Proposal for Supplement 13 to the 04 series of amendments to Regulation No. 44 (Child Restraint Systems)

The text reproduced below was prepared by the expert from the Netherlands, aimed at excluding diverging interpretations with regard to child restraint systems in UN Regulation No. 44 and supersedes ECE/TRANS/WP.29/GRSP/2016/18. The modifications to the current text of the UN Regulation are marked in bold for new or strikethrough for deleted characters.

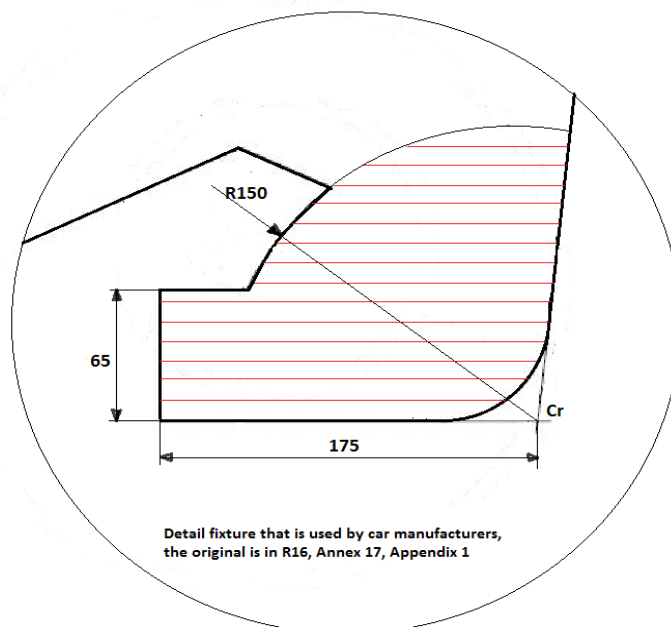
"6.1.8. Child restraint systems of the "universal" category, except ISOFIX universal child restraint systems, shall have a main load-bearing contact point, between the child restraint and the adult safety-belt. This point shall not be less than 150mm from the Cr axis when measured with the child restraint on the dynamic test bench installed in accordance with Annex 21 to this Regulation without a dummy. ~~This shall apply to all adjustment configurations. Additional alternative belt routes are allowed.~~

Moreover, in the zone with red horizontal lines, there may be contact by means of flat support of the adult safety belt, however, no part of the child restraint shall hinder the lap belt of the adult from following its intended design and use.

The main load-bearing contact point is the part of the child restraint that makes that the lap belt will sustain tension forces in the longitudinal direction and transverse forces from the restraining function.

Figure 1A
Standard seat belt configurations, for dynamic test

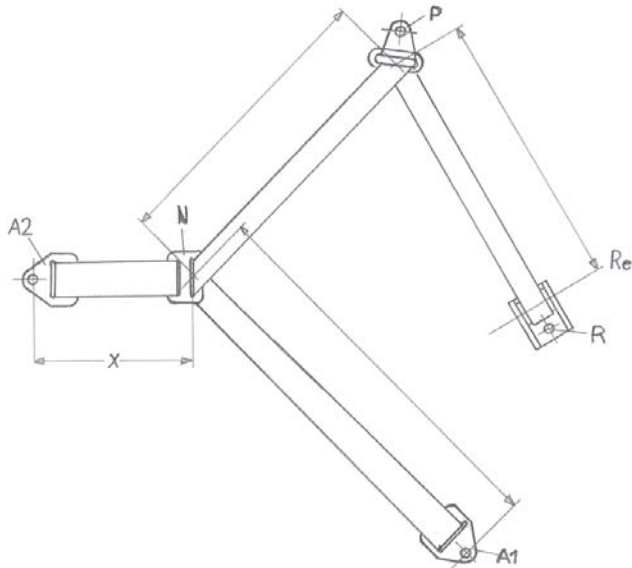
Annex 13, Figure 1, amend to read:

Figure 1B
Standard seat belt configuration, for fitting session of par.6.2.12.dynamic test

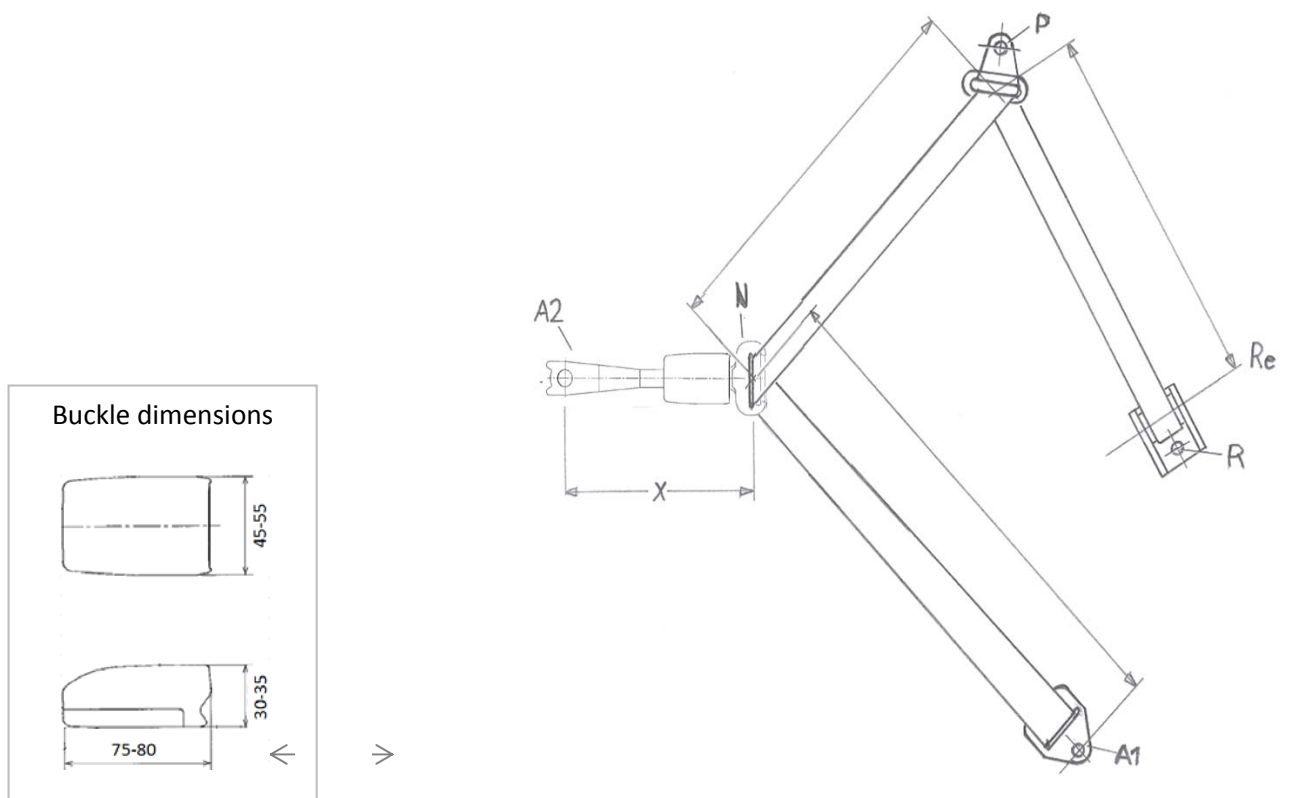
- "6.2.12. In case of booster cushions, the ease with which the straps and tongue of an adult belt pass through the fixture points shall be examined. This goes particularly for booster cushions which are designed for the front seats of cars, which may have long semi-rigid stalks. The fixed buckle should not be allowed to pass through the fixture points of booster seats, or to permit a lie of belt completely different from that of the test-trolley. **This shall be tested during a separate fitting session on the test bench having replaced as well the central part of the standard safety belt (figure 3 of Annex 13) as part A2 with its X mm of flexible strap length, by respectively a tongue and a generic buckle on a stalk, both together projecting 150 mm outside the Cr point.**"

3. The type approval administration of the Netherlands is confronted with a CRS that forces the lie of the adult belt in real cars completely different from the lie on the test-trolley. Regulation No. 44 mentions a judgment using buckles, but does not further specify anything to have a proper judgement. To prevent incompatibilities in real cars, this paragraph aims to introduce a better check.
